B2B Excellence Ltd. (Extension Buildings)

Purbapara Mirzapur, 8 No. Mirzapur Mouza, Mirzapur, Gazipur Sador, Gazipur
(24.08869, 90.35672)
15th November 2021

Observations

FOOTING SCHEDULE :

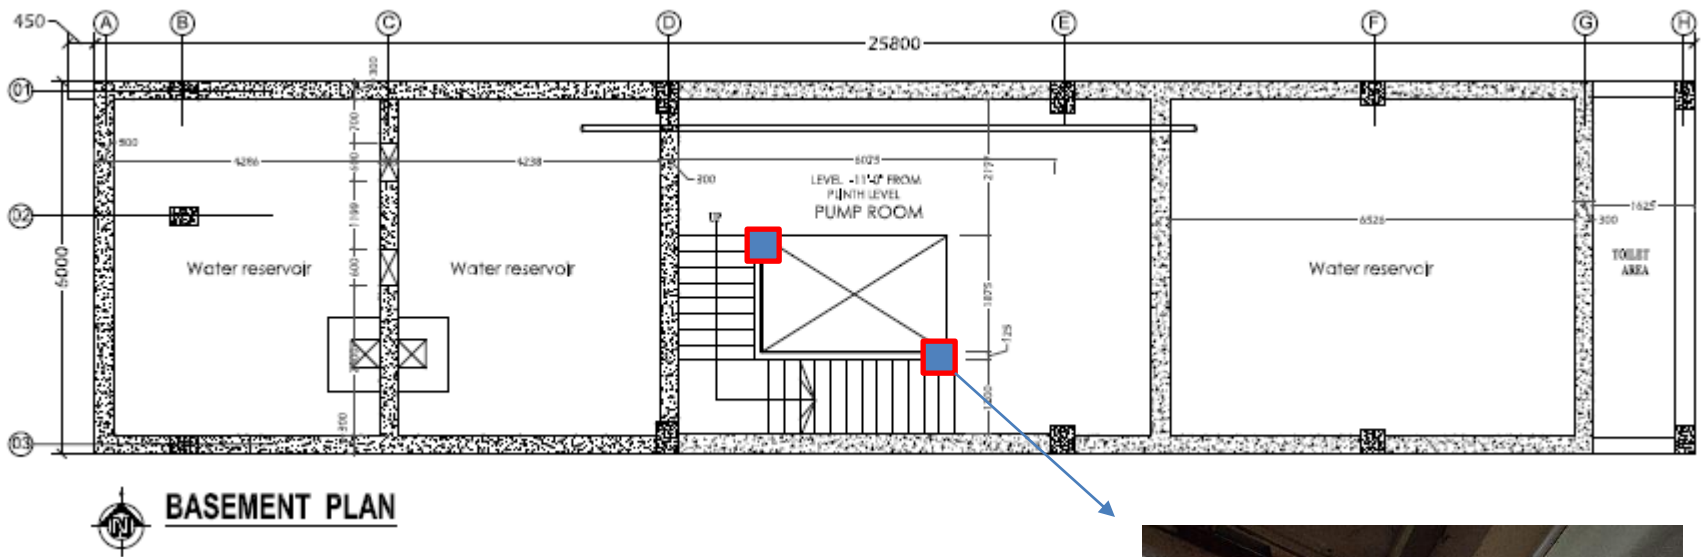
Footings area mentioned in the engineering assessment report not matched with the as-built drawing. Building engineer is required to review the design of the footings.

Two additional column found on the basement floor but not shown in the drawing. Building engineer is required to update the as-built drawings

LEGEND OF I-SECTION

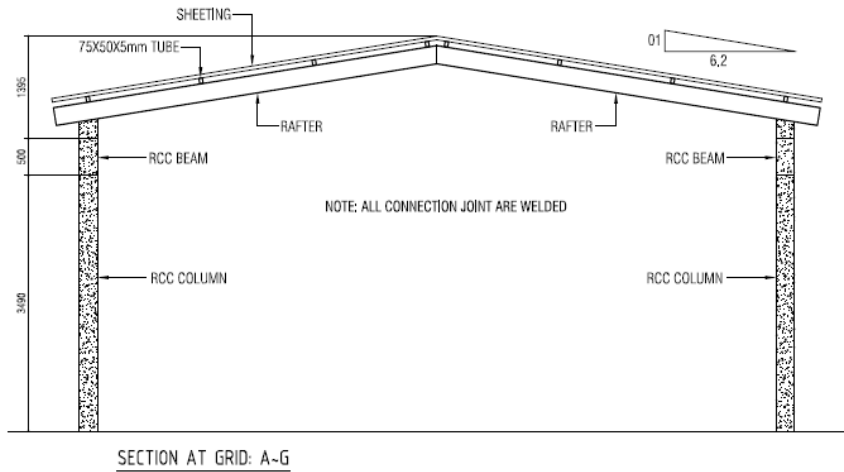
Rafter depth shown 250 mm on as-built drawing, but depth measured 200 mm onsite. Building engineer is required to update the as-built drawings.

SECTION

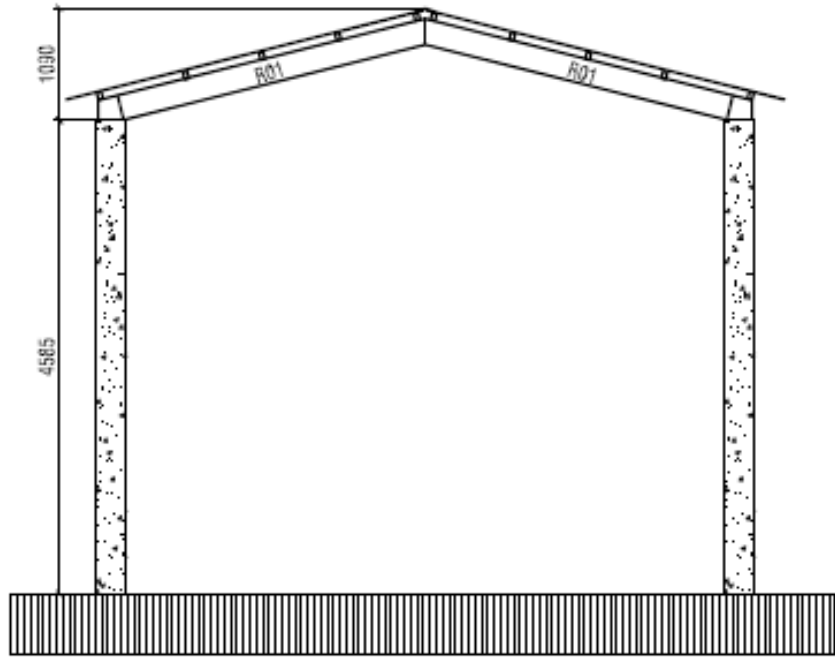
Rafter depth shown 250 mm on as-built drawing, but depth measured 200 mm onsite. Building engineer is required to update the as-built drawings.

Wastage Shed

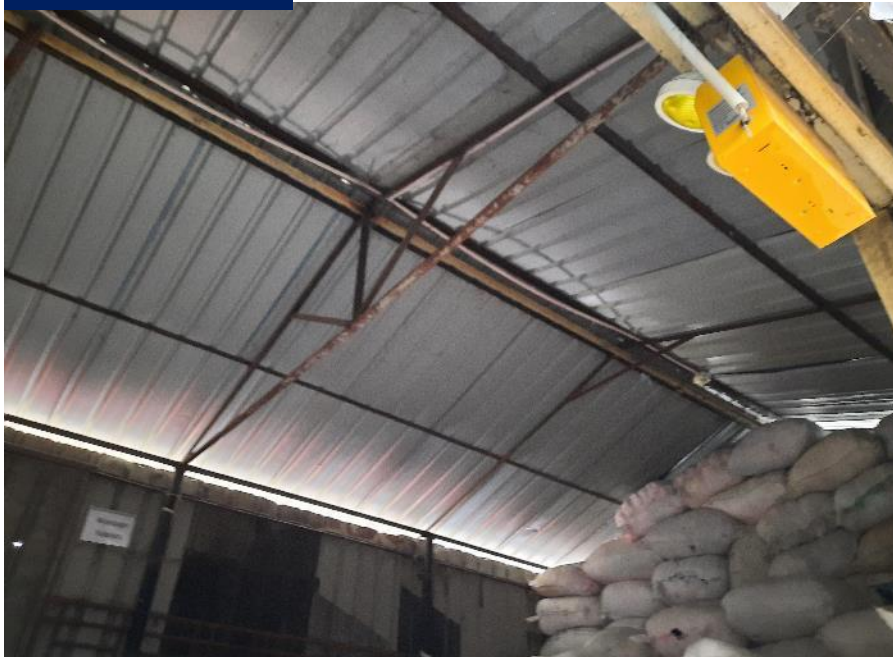
Inadequate member size, lack of lateral stability system and poor connection details observed. Building engineer is required to replace the structure.

Inadequate member size, lack of lateral stability system and poor connection details observed. Building engineer is required to replace the structure.
